**Addendum to
Negative Declaration
for
Pacific Gas and Electric Company's
Relief Reach – Kennedy Meadows
Riparian Restoration and Streambank Stabilization Project**

SCH No. 2017062016

Addendum Prepared by Cardno

July 2022

Figure 1-1 Kennedy Meadows Project – Treatment Areas 1 and 7.

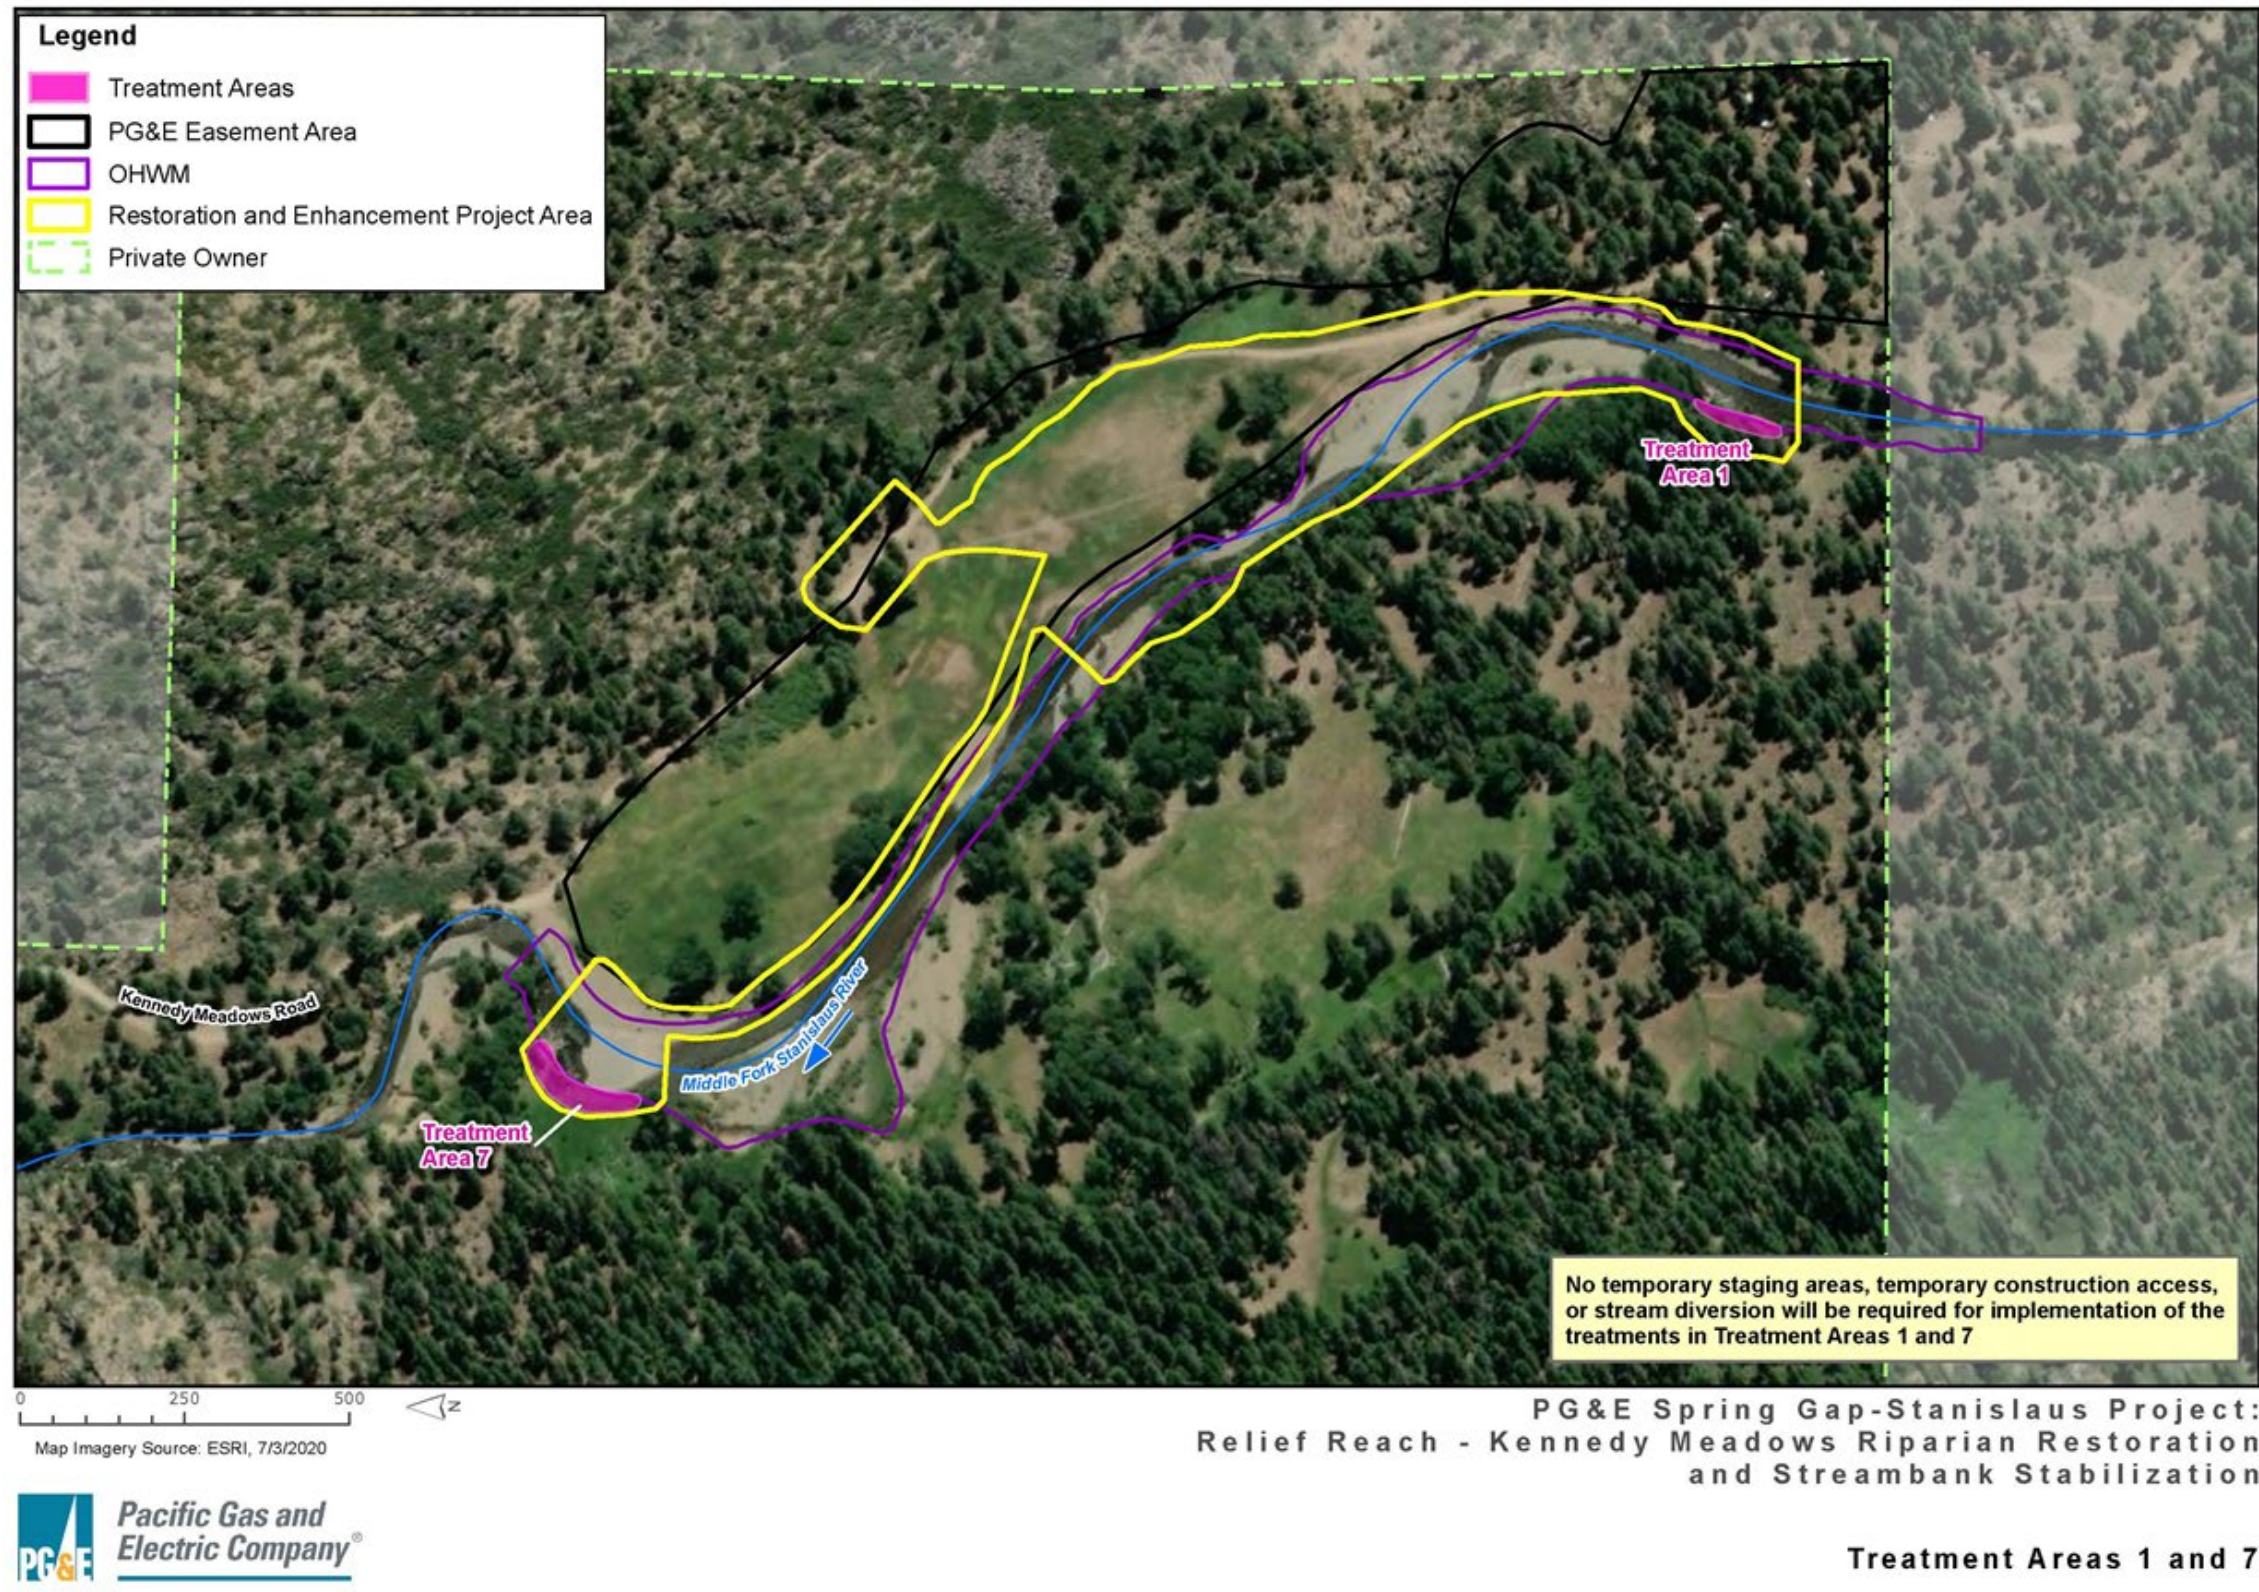
As originally evaluated in the 2017 IS/ND, the Project included seven locations within the Project Reach where bank stabilization and riparian restoration treatments would occur. Each of the treatment areas were subject to modification through bioengineering, streambank grading, rock and wood placement, and riparian vegetation planting. As originally proposed, the majority of the Project has been constructed, monitored, and managed. Construction and planting were completed at five of the seven sites in October 2017, but construction work for the two remaining treatment areas, known as Treatment Areas 1 and 7, was deferred (Figure 1-1).

After 2017, PG&E re-evaluated the originally proposed construction work for Treatment Areas 1 and 7 (which included a combination of rock and large wood placement and vegetation plantings, as well as bank grading) and now proposes to achieve the bank stabilization and riparian restoration objectives for the Project Reach by densely re-vegetating the toe of bank, bank slope, and top of bank by planting only for Treatment Areas 1 and 7. The new proposal has no construction-related disturbance, fill, or related impacts, as all planting work will occur via hand tools. The proposed modification for Treatment Areas 1 and 7 is further described below:

- **Treatment Area 1:** The originally proposed bank stabilization treatment techniques included large wood placement of two logs, placement of 41.3 cubic yards of rock, and planting of approximately 25 riparian poles/containers along 130 feet length of bank. In lieu of this work and any associated construction disturbance, approximately 120 riparian poles/containers would be planted and seeded by hand.
- **Treatment Area 7:** The originally proposed bank stabilization treatment techniques included bank grading, large wood placement of 14 logs, placement of 35.1 cubic yards of rock, and planting of approximately 87 riparian poles/containers along 250 feet length of bank. In lieu of this work and associated construction disturbance, approximately 800 riparian poles/containers would be planted and seeded by hand.
